**REVISED PRELIMINARY STAFF REPORT  
2009-2010 SOUTH COUNTY AREA PLANS REVIEW**

**APR ITEM:** 09-I-2L

**PROPOSED PLAN AMENDMENT:** Add an option for mixed use development up to 1.85 FAR.

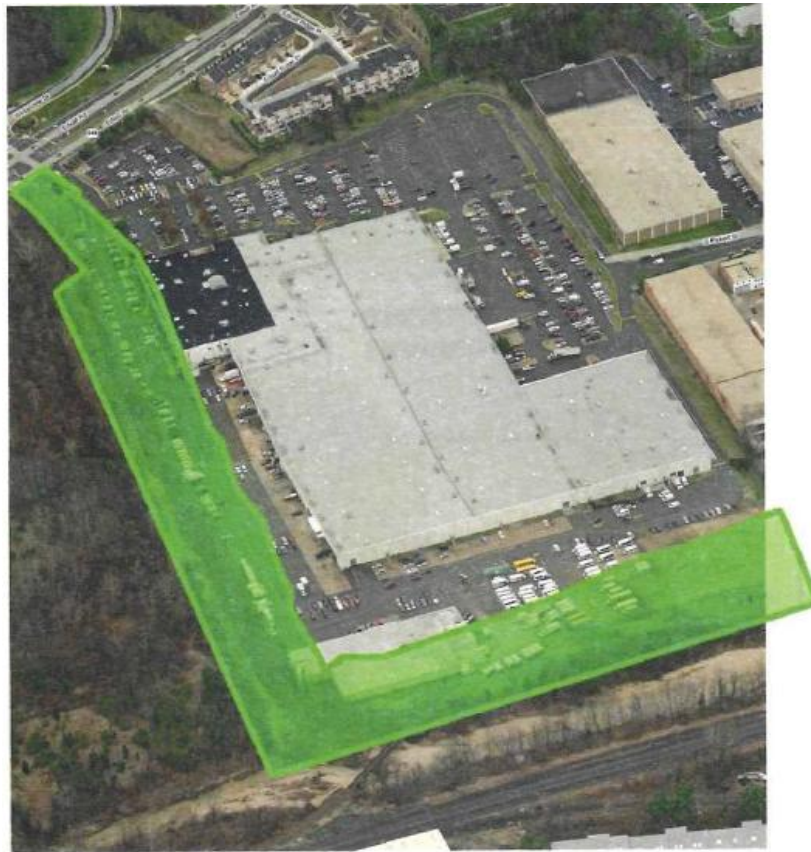
- The current Plan nomination proposal for 2.29 or 2.45 million square feet of mixed use development consisting of 650,000 or 736,000 square feet of office use, 14,000 square feet of retail use, 1,357 or 1,394 residential dwelling units and 260 or 300 hotel rooms raises concerns about the compatibility of the proposed use and intensity with the existing

surrounding community. Picket Street east of the nominated parcel, is currently developed with light industrial and retail uses, Bren Mar Park and residential townhomes are developed to north and planned to the west. Given these established uses, the proposed use and intensity are out of character with the surrounding area.
